AMENDMENT NO. 3 JULY 2015
TO
IS 694 : 2010 POLYVINYL CHLORIDE INSULATED UNSHEATHED AND
SHEATHED CABLES/CORDS WITH RIGID AND FLEXIBLE CONDUCTOR FOR RATED
VOLTAGES UP TO AND INCLUDING 450/750 V

(Fourth Revision)

Amendment No. 3 to IS 694 : 2010

FIG. 1 PREFERRED ARRANGEMENT OF MARKING

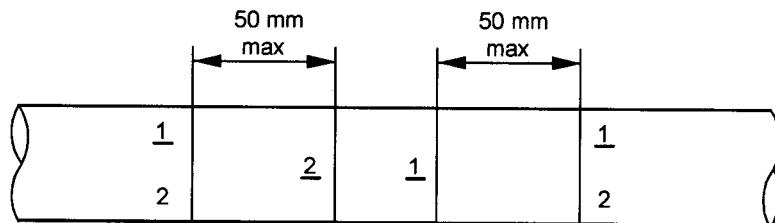
(Page 6, Fig. 1) — Substitute the following ‘Fig.1’ for the existing:
